Module 0 Build Progression

ArgonCube Engineering Meeting

February 28th, 2020

Anode Pre-Assembly

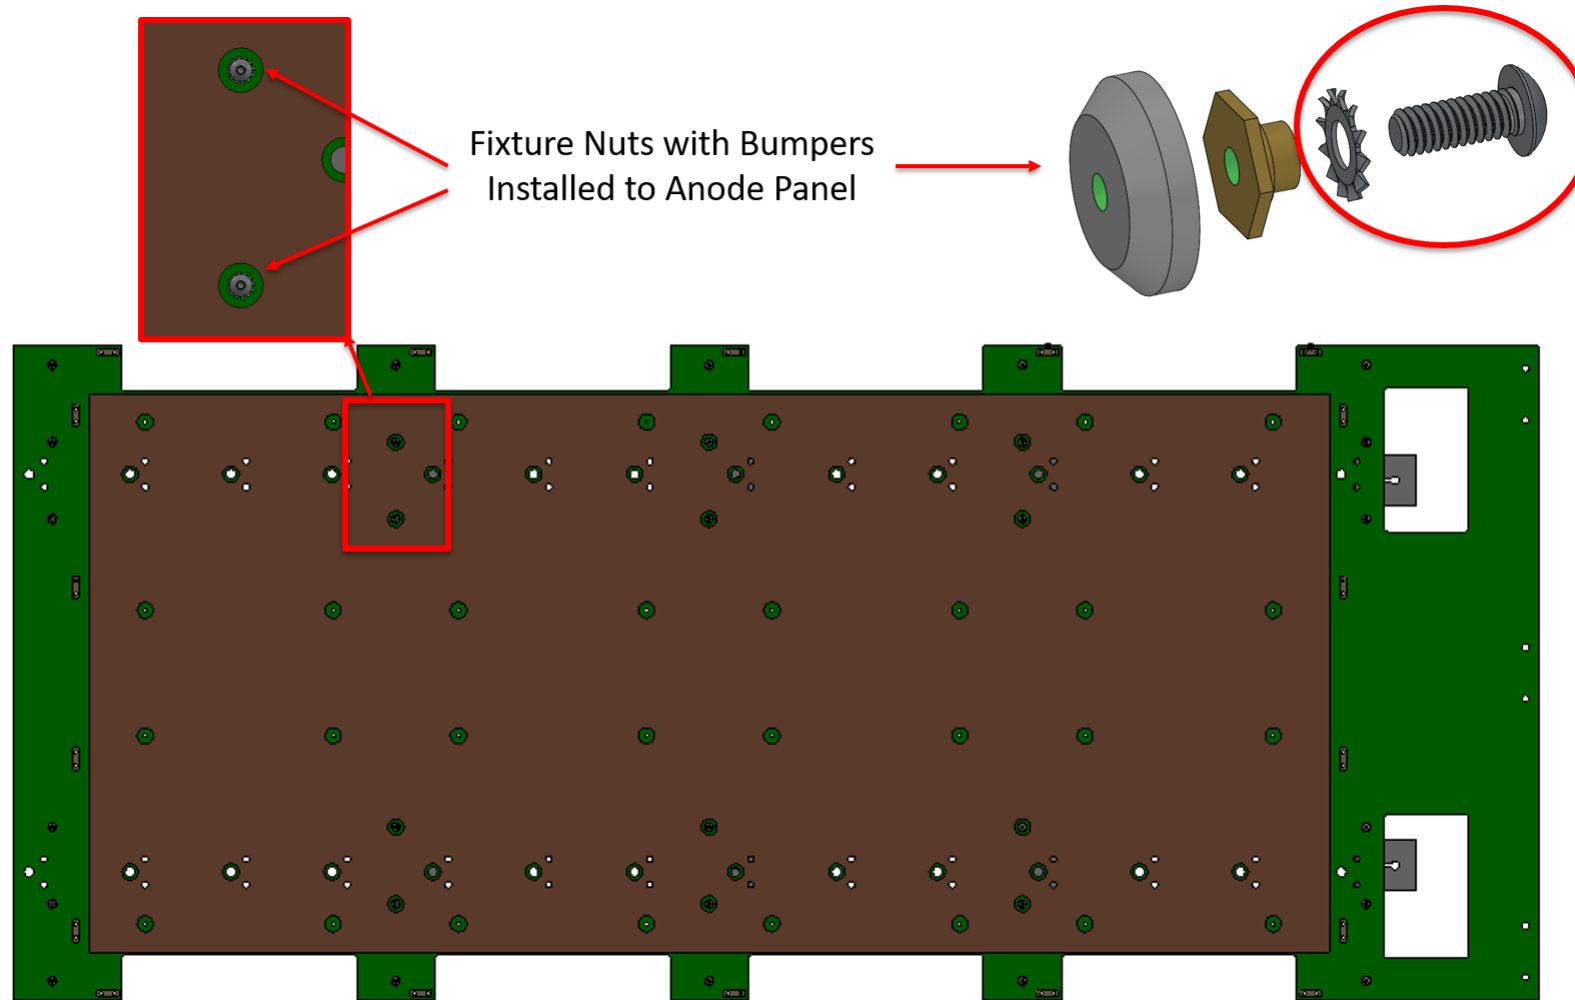
Would be possible to receive the anode panel from SLAC with this pre-assembly completed?

ArcLight vs LCM – Design Question

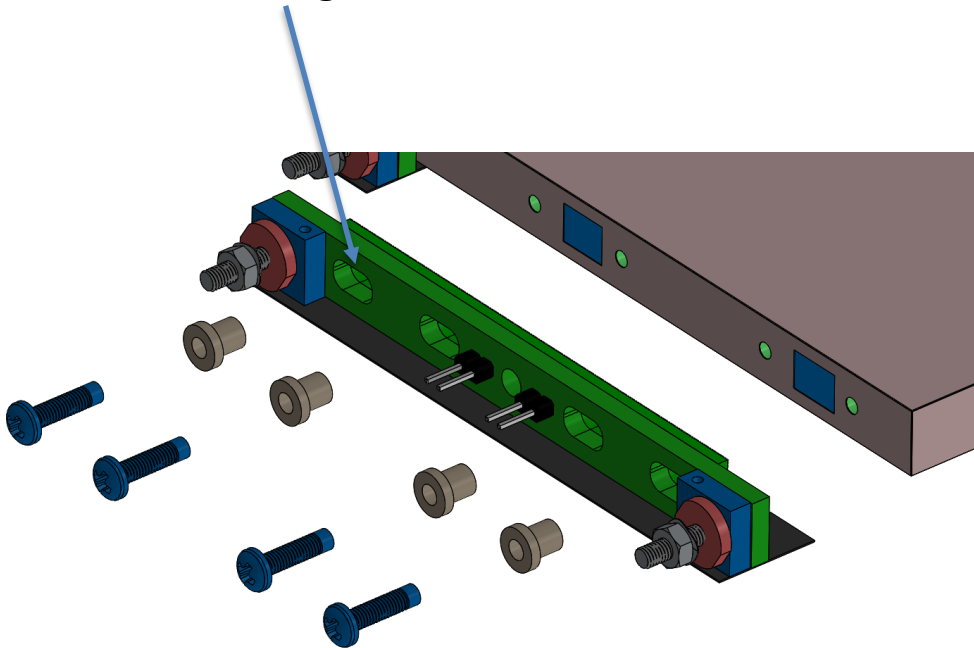
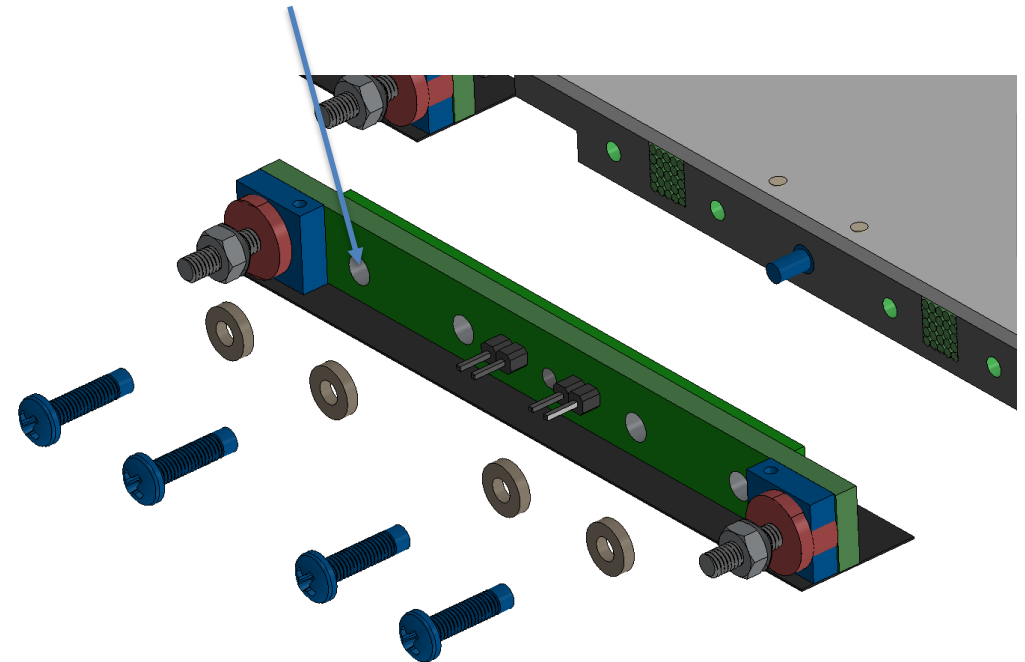
Slotted in ArcLight

Not Slotted in Fiber LCM – does this need slots?

Assume this is due to material differences between the ArcLight and Fiber LCM, but want to verify that this is the case. Cost-wise it would be nice if this could be the same part but maybe not possible?

Light Readout Installation to Anode Panel – ArcLight & Fiber LCM

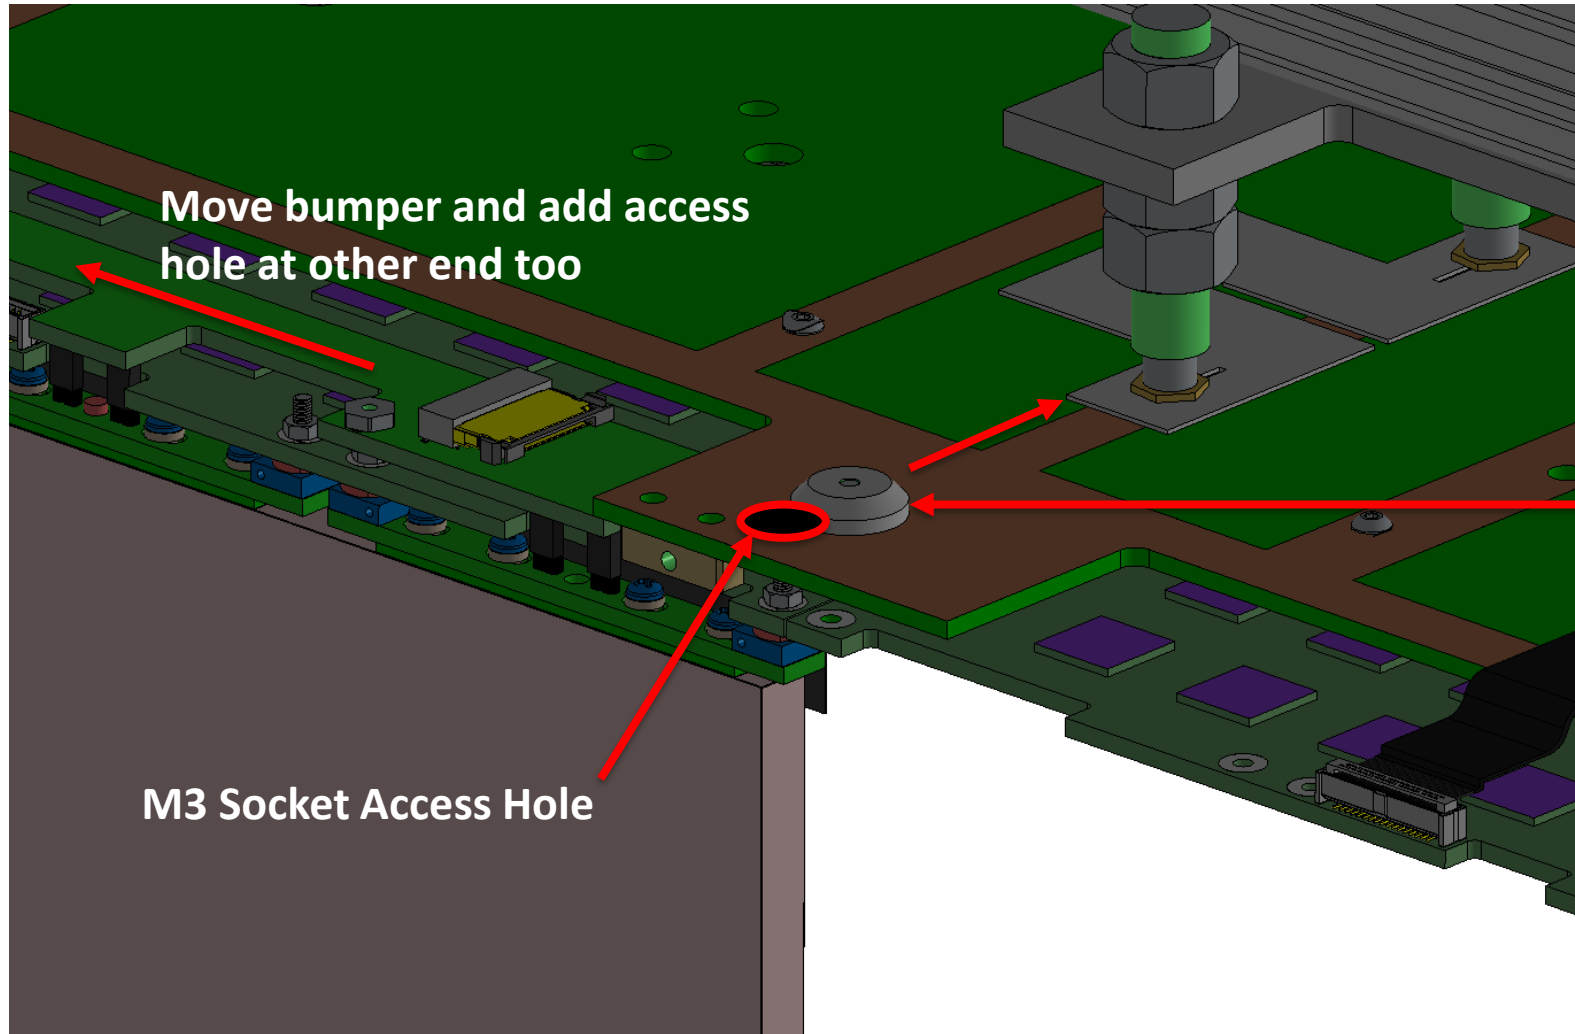
Can this bumper be moved in the direction indicated and a socket access hole put in the anode panel for easier access to the this nut? We should be able to swap out a light readout without removing the pixel board as well. This should be done at all bumpers at this outside location, and M3 socket access ports machined into panel at all locations

Samtec FCF8-20-01-L-03.00-S

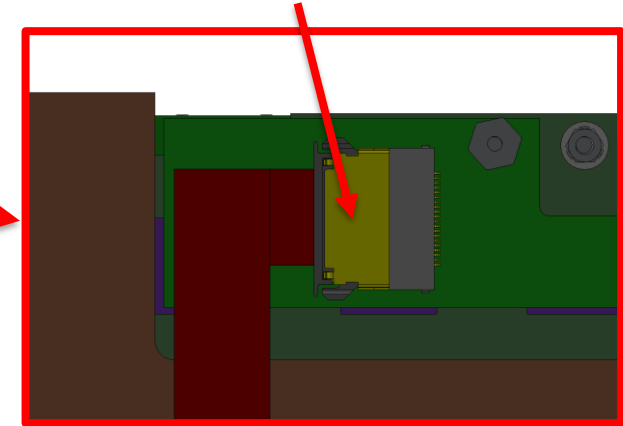
Is this socket not used or are we missing cable in CAD model?

Cathode Assembly

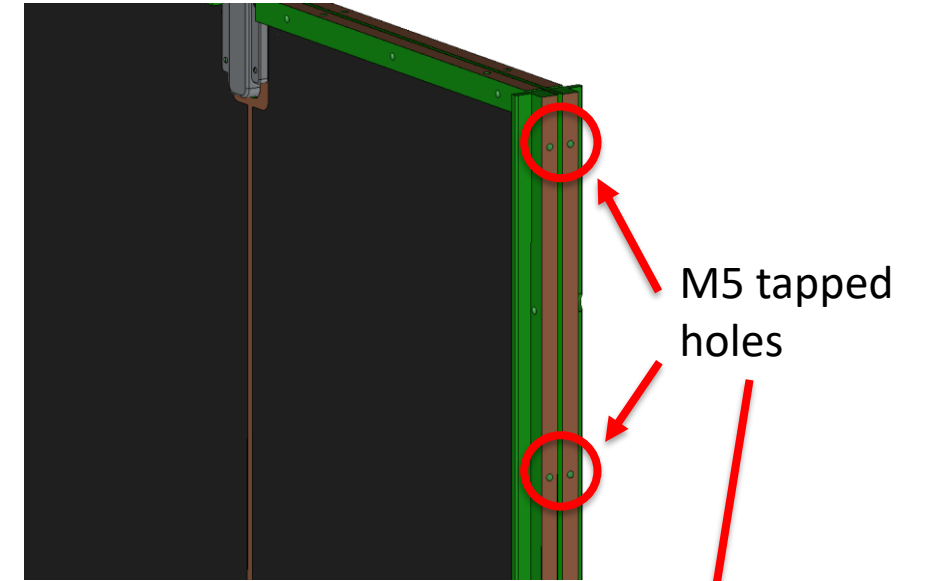
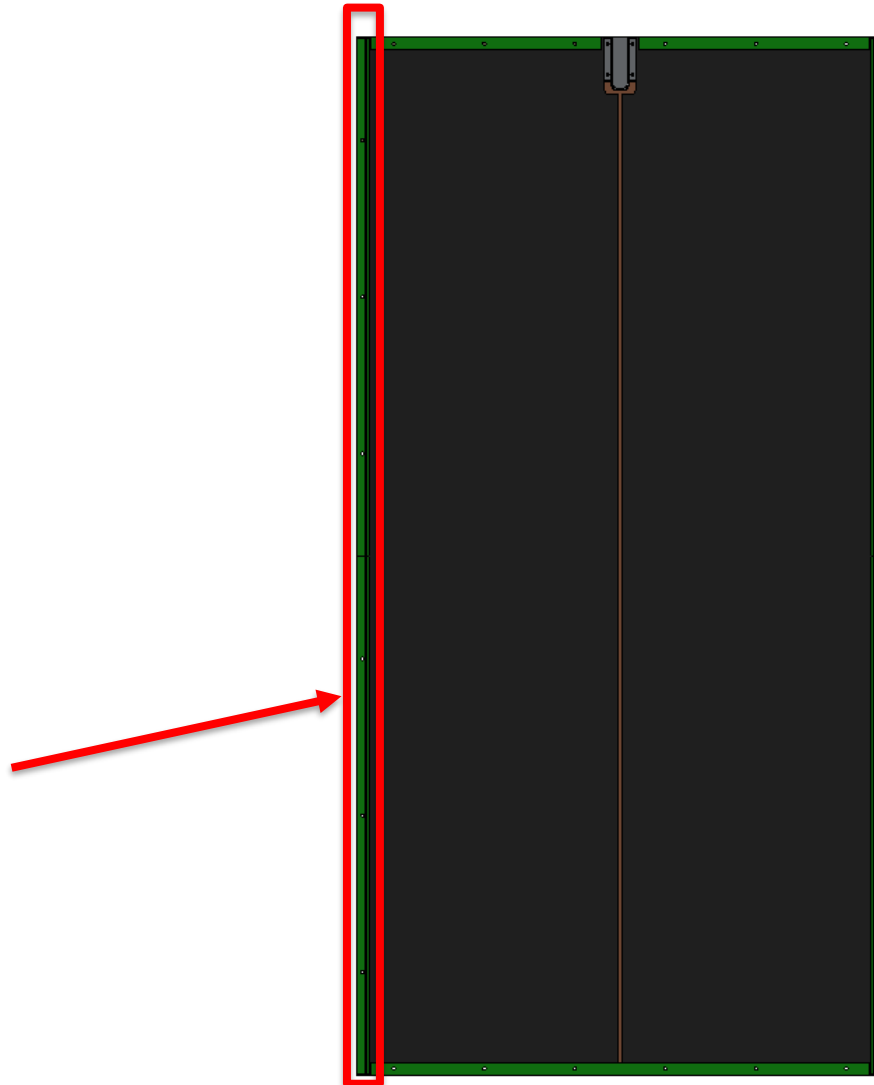
How is cathode held for assembly of other components?

- Possible to stand it up on a clean surface on the floor, but would require someone to constantly hold it from tipping over – not ideal
- Could design a T-slot structure that engages with tapped holes on the cathode brackets

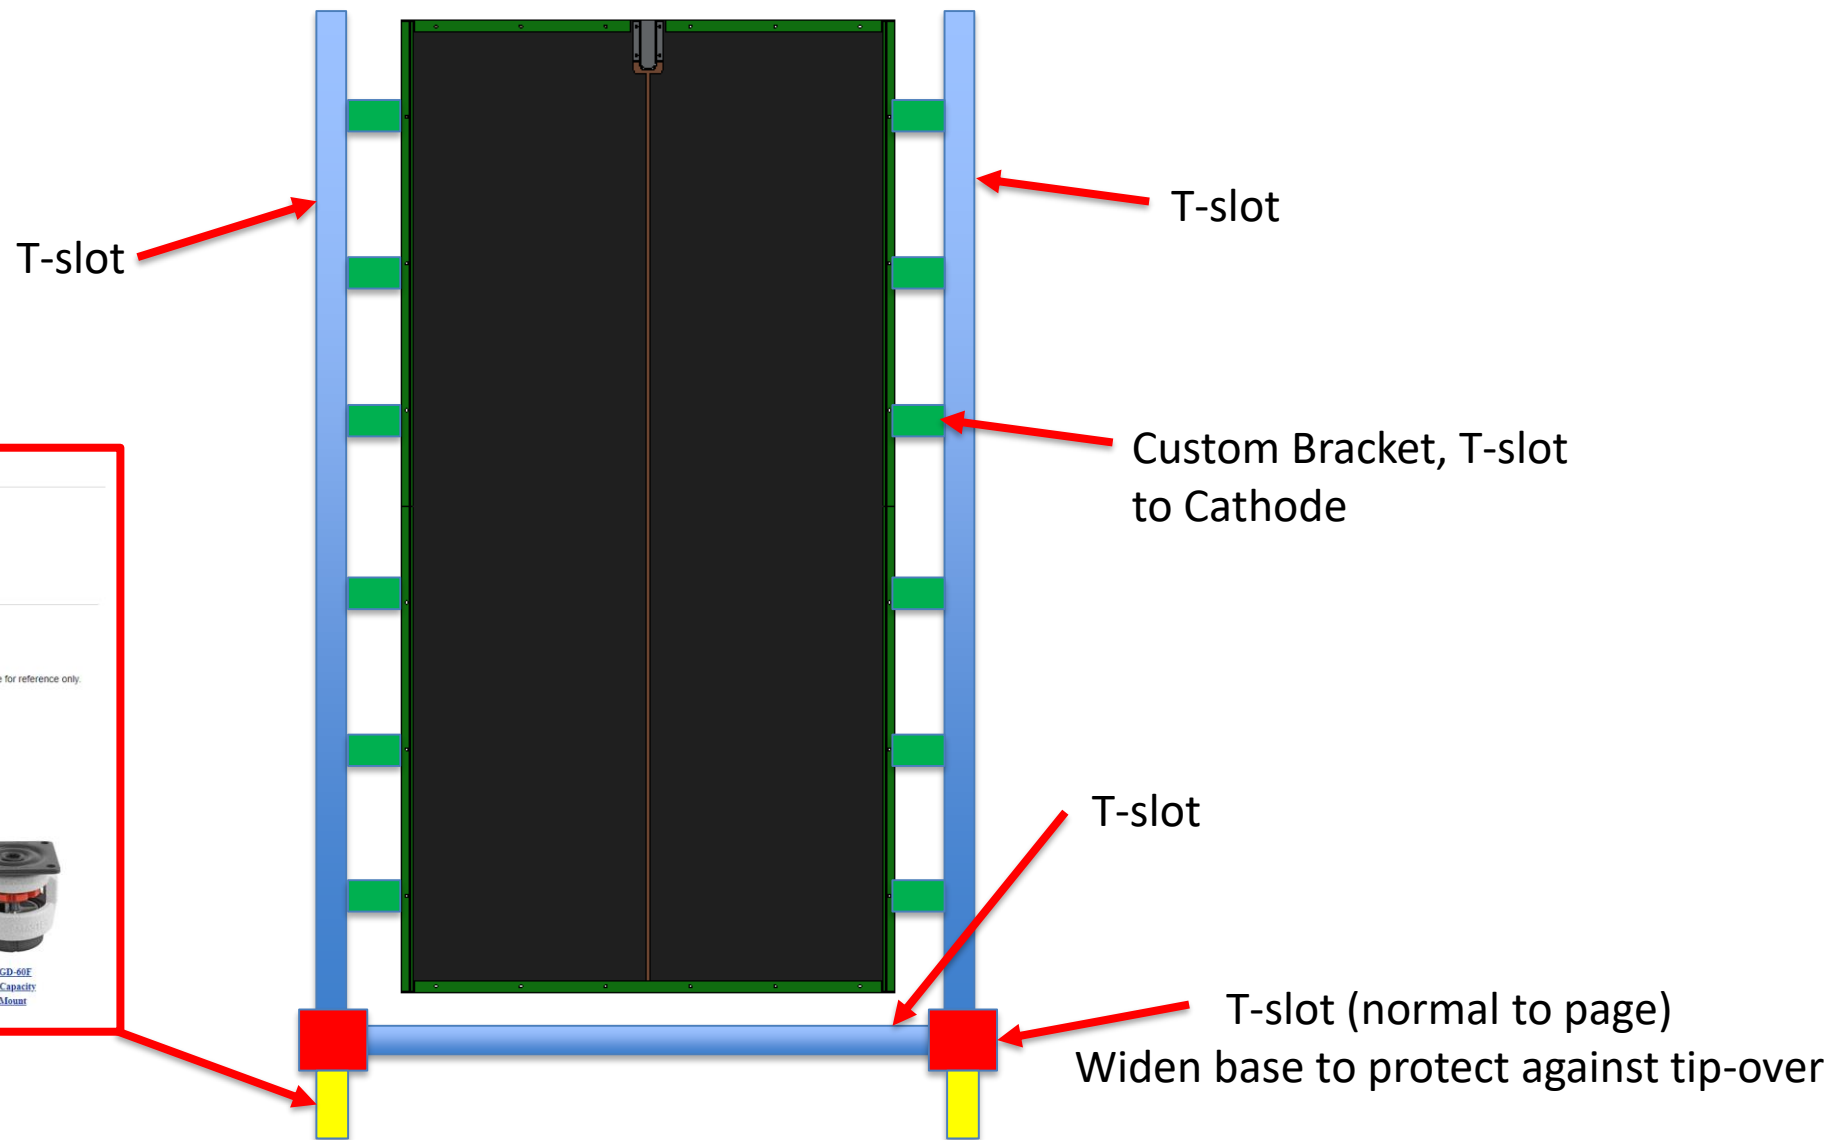
Do these holes have a threaded insert?

Bring in Module Top Flange

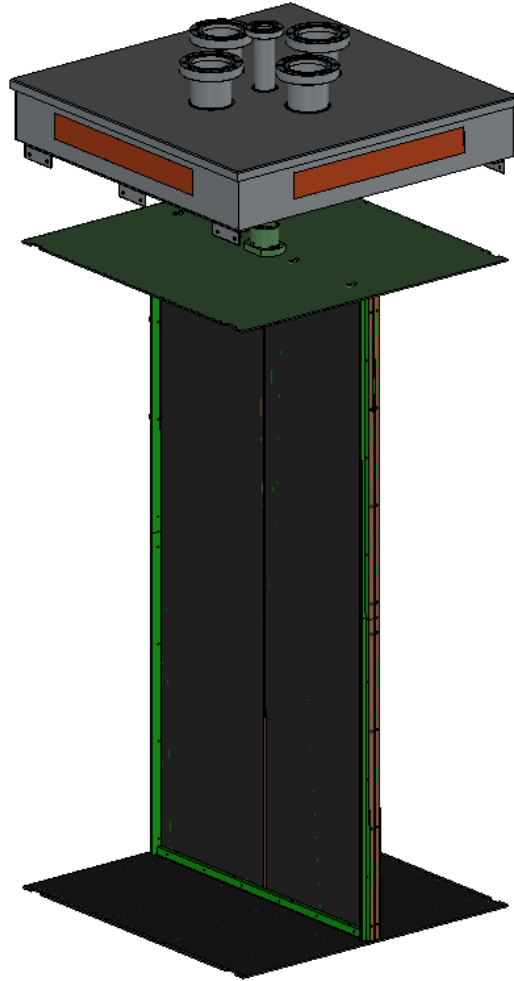
How is the Module Top Flange held during assembly?

- We want to avoid suspending it from a ceiling crane – unsteady, suspended load, not ideal for end of day
- A rigid assembly fixture would be the best solution – designed to hold the full weight of the Module with margin
- This could be a T-slot structure again with some custom parts that interface to the bolt pattern on the top of the module flange
